File Ref: EXT/2022/0009

13 December 2022

**SSD-35962232- Burrows Road Multi-level Warehouse, St Peters**

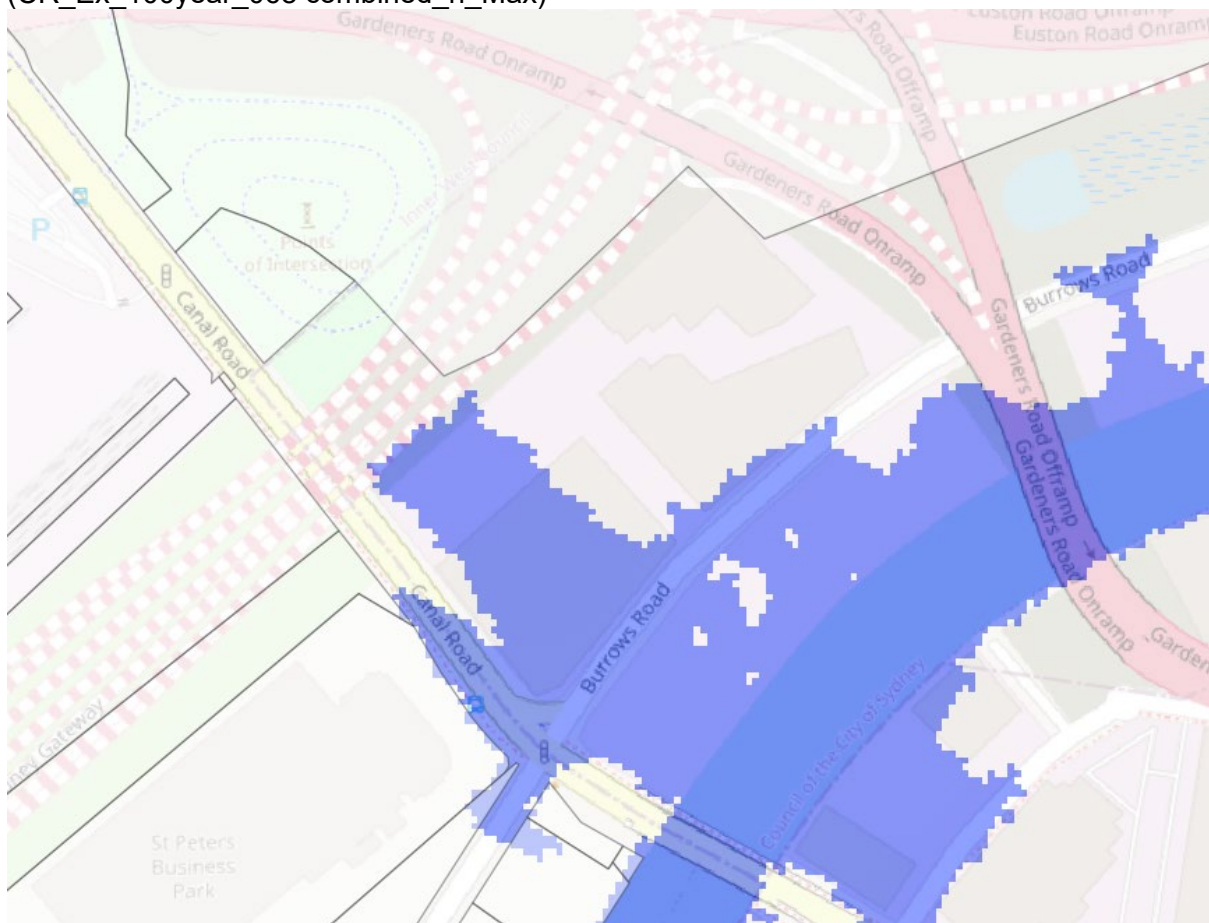
The SEE for the MOD 12 approval found that the Level of Service (LOS) for the intersection of Burrows Road/Burrows Road South/ Ricketty St/Canal Road was an **F** in the afternoon peak (Table 6.4) and the LOS at the intersection of Canal and the Princes Highway will also an **F** in the morning Peak. This is in contrast to the LOS of B and D found by the Anson Group for these intersections (Table 17). The discrepancies in the two traffic assessments must be explained.
